SEMINOLE COUNTY GOVERNMENT
 1101 EAST FIRST STREET, 2ND FLOOR, WEST WING
 SANFORD, FLORIDA 32771

PROJECT NAME:	ROOFING USA - PRE-APPLICATION	PROJ #: 23-80000144
APPLICATION FOR:	DR - PRE-APPLICATION DRC	
APPLICATION DATE:	10/10/23	
RELATED NAMES:	EP VINCENT PELUSO	
PROJECT MANAGER:	MAYA ATHANAS (407) 665-7388	
PARCEL ID NO.:	19-21-30-529-0000-0010	
PROJECT DESCRIPTION	PROPOSED SITE PLAN FOR AN OFFICE BUILDING ON 0.63 ACRES IN THE PD ZONING DISTRICT LOCATED ON THE WEST SIDE OF S US HWY 17-92, SOUTH OF E ALTAMONTE DR	
NO OF ACRES	0.63	
BCC DISTRICT	4-Amy Lockhart	
CURRENT ZONING	PD	
LOCATION	ON THE WEST SIDE OF S US HWY 17-92, SOUTH OF E ALTAMONTE DR	
FUTURE LAND USE-	COM	
SEWER UTILITY	SEMINOLE COUNTY UTILITIES	
WATER UTILITY	SEMINOLE COUNTY UTILITIES	
APPLICANT:	CONSULTANT:	
RODNEY JAMES R.W. JONES CONSTRUCTION INC 250 OWL HAVEN CV GENEVA FL 32732 (407) 925-5910 RODNEY@RWJONESCONSTRUCTION.COM	VINCENT PELUSO AMERICAN ENG. & SURVEY INC 4250 ALAFAYA TRL STE 212-138 OVIEDO FL 32765 (407) 732-1263 VINCENT@AMERICAN-ENGINEER.COM

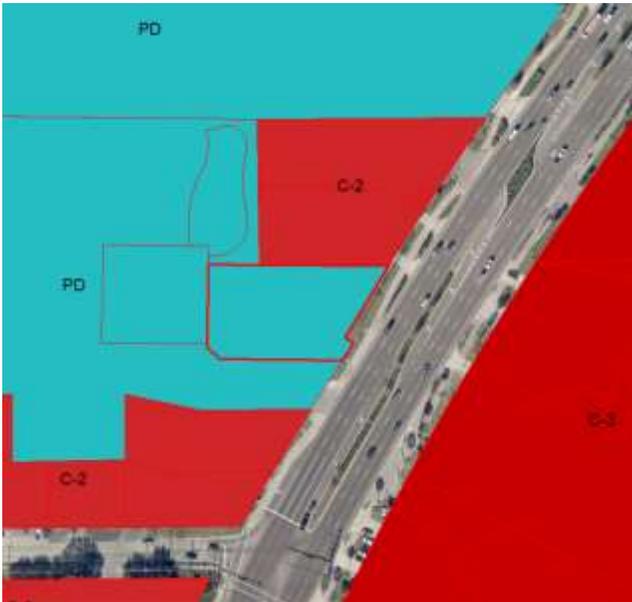
- Property is within a PD and shall be developed in accordance with the approved PD Developer's Commitment Agreement (DCA) and Master Plan. Certain conditions in the DCA include pedestrian accessibility, orienting the parking in the rear of the building, and certain setbacks as listed in the enclosed comments.
- The proposed project is subject to Site Plan Review Process: SCLDC Chapter 40. Information can be found at: <http://cdn.seminolecountyfl.gov/departments-services/development-services/planning-development/development-processes-requirements/index.shtml>
